REV. NO.	990-205-04	SHT	REV.	F
ECOM	REV.	DESCRIPTION	REV.	REV.

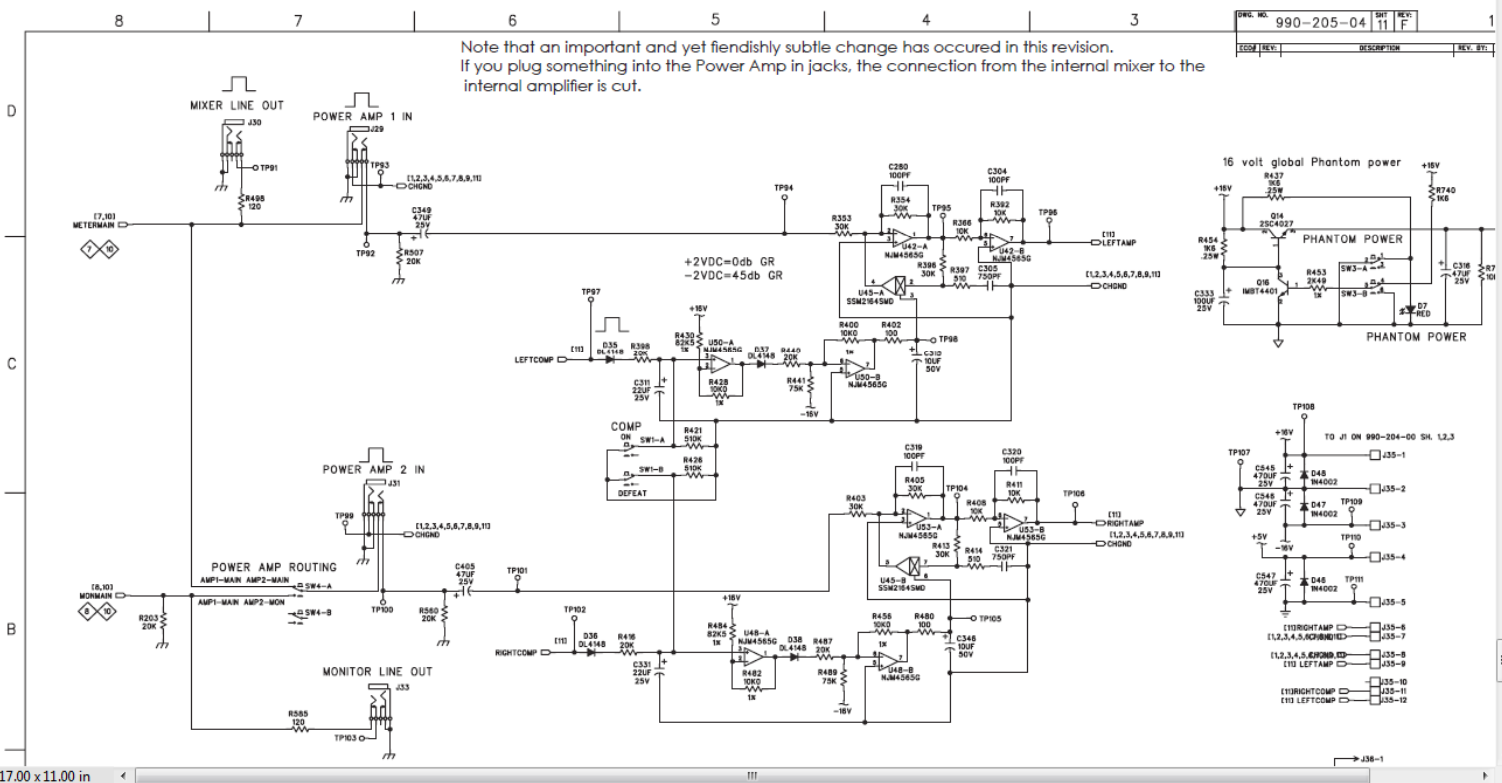
Note that an important and yet fiendishly subtle change has occurred in this revision.
 If you plug something into the Power Amp in jacks, the connection from the internal mixer to the internal amplifier is cut.
